Amendment A

Attorney Docket No: 3926,136 Response to Notice of Non-Compliant Amendment

Response to Notice of Non-Compliant Amendment

## Appendix: Figures 1a, 1b and Figure 2

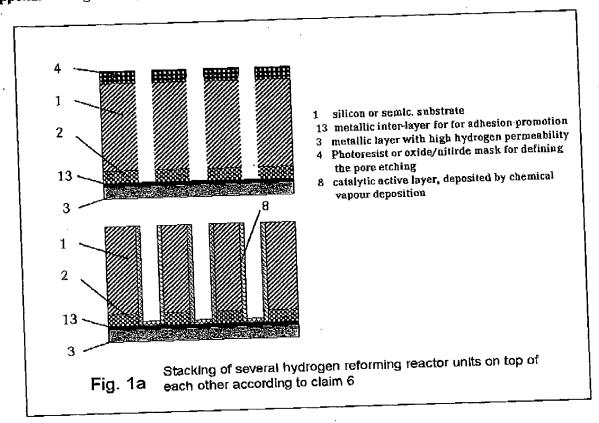
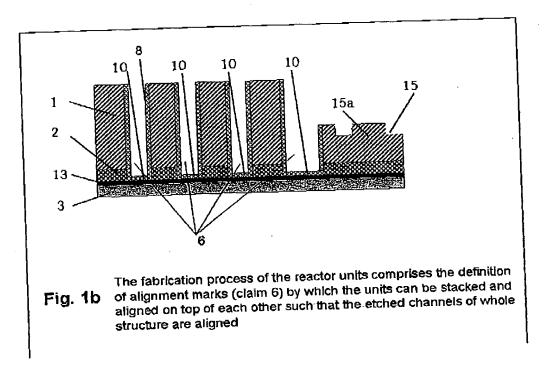
Applicants have drawn two figures to make the 2 variants of combining or stacking of the processed reactor segments clear.

a) either stacked on top of each other forming a hydrogen reforming reactor (see Fig. 1a +b in Apendix)

b) two rector elements can be combined to and oppositely aligned to an "interdigit" structure schematically depicted in Fig. 2 in Appendix . This streture is well suited to the envisaged application of steam reforming reactor which creates hydrogen for fuel cell systems.
